Appl. No. 10/731,496  
Amdt. dated April 4, 2007  
Reply to Office action of March 13, 2007

### AMENDMENT TO THE DRAWINGS

Fig. 4

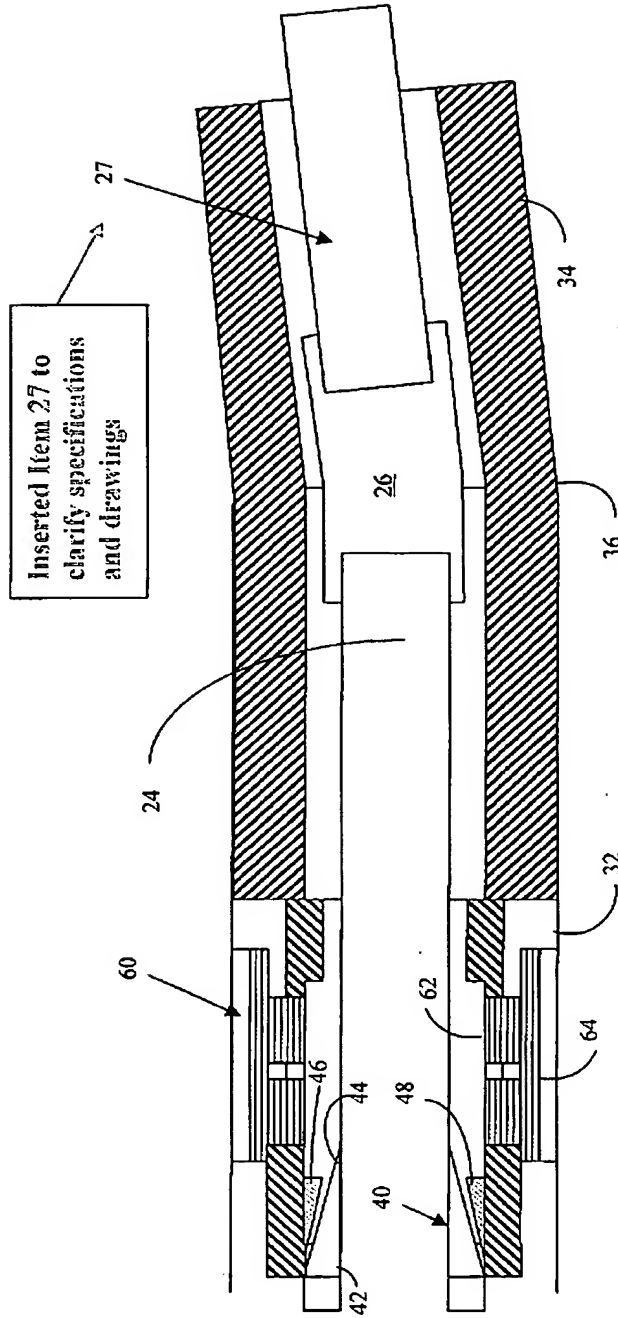
- Fig 4.
  - o Numerical call out for Item 27 was inserted to provide clarity
